TITLE - Plan layout				NIHVA TECHNOLOGIES PVT. LTD.
QTY -				
NAME	SIGN	DATE		
DRAWN	H. B.	03/08/23		CLIENT - NTPL-183-HP
CHECK	P. M.	03/08/23		LOCATION -Ahmedabad
APPRD.	V. T.	03/08/23		PRODUCT - Retractable roof
If any queries contact : supportautomation@nihva.com				DWG NO - NIHVA\22-23\NTPL183 REV-1
ALL DIMENSION ARE IN mm				SCALE: SHEET:

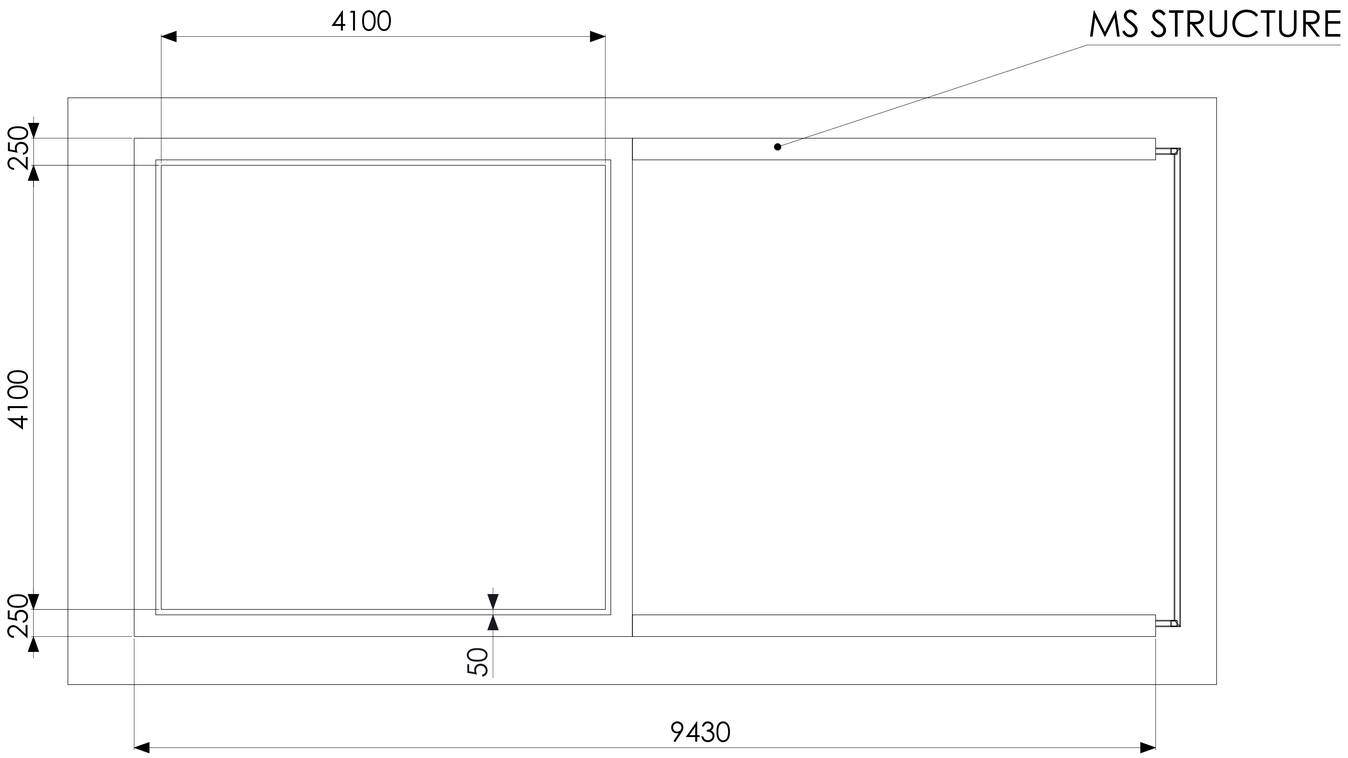
note:
1) current top civil structure is approx 92 mm in depth
need to increase the depth of top civil structure to atleast **180 mm**
2)top surface shoud be of **smooth granite of 16 mm** thk for track
3)parapet wall shoud be constructed of **50 thk and 60 mm hight**
avoid water flowing inside cutout
